RE: Grading and Drainage Plan for Dion's at Cottonwood Mall (B13/D18) Submitted for Site Development Plan For Building Permit Approval and Building Permit Release, Engineer's Stamp Dated 5/13/99.

DRB-98-192 Alex Harrison, Architect, agent for Dion's, requests Site Development Plan for Building Permit approval for Tract C-5A, Cottonwood Mall, zoned SU-1/RC (City) and located on Coors By-Pass NW between Coors NW and Seven Bar Loop Rd NW containing approximately 1.31 acres. [REF:Z-96-40, DRB-90-361, DRB-96-496) (B-13)

Dion's Restaurant #8
Cottonwood Shopping Center, Albuquerque, NM

SITE PLAN sheet number

SITE PLAN
SCALE: 1\"/>

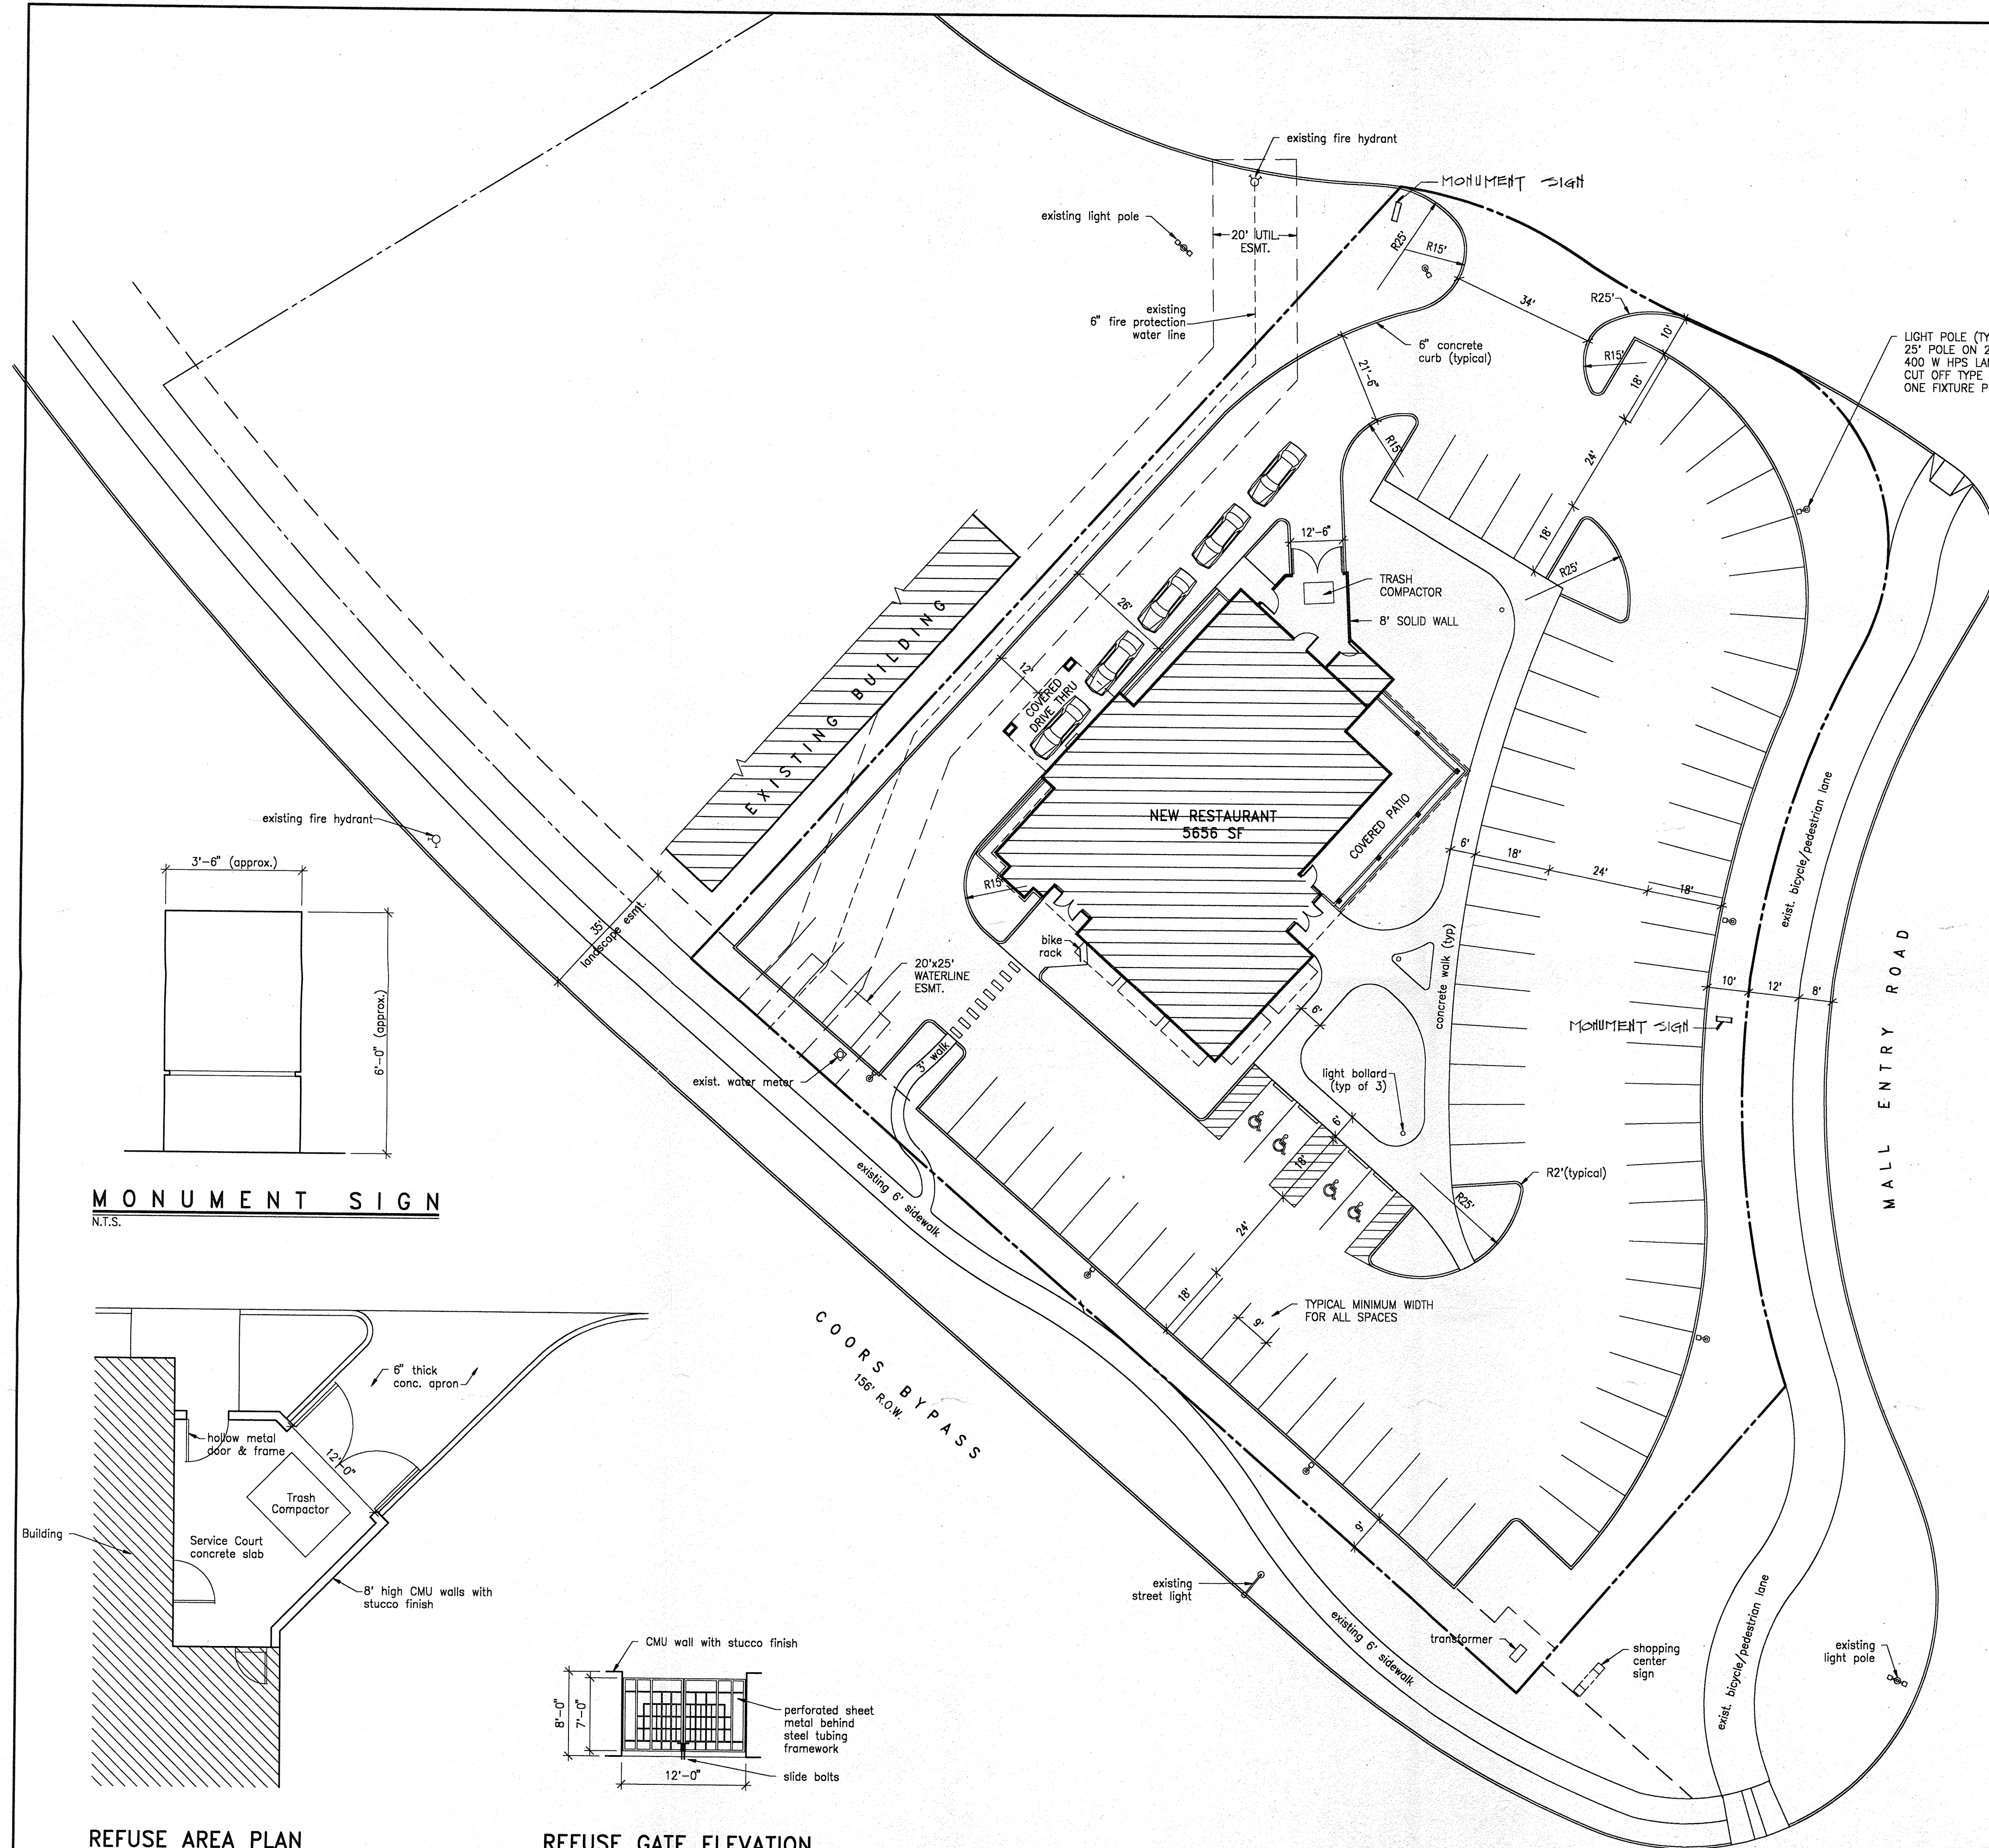
1. A landscaping plan should be provided.
2. The drive-thru area needs to be restricted to one-way operation. The southern end of this area needs to be signed, and narrowed. Has the Refuse department approved the dumpster location?
3. The min. sidewalk width connecting this site to the Coors-by-Pass is 4ft.
4. The two parking spaces at the northwest are near the entrance needs to be removed.
5. Does the area masterplan/site plan for subdivision permit the drive-thru? The TIS?
6. Show both sides of the mall loop road with the aisles to ensure that appropriate aisle/site entrance configuration is provided.
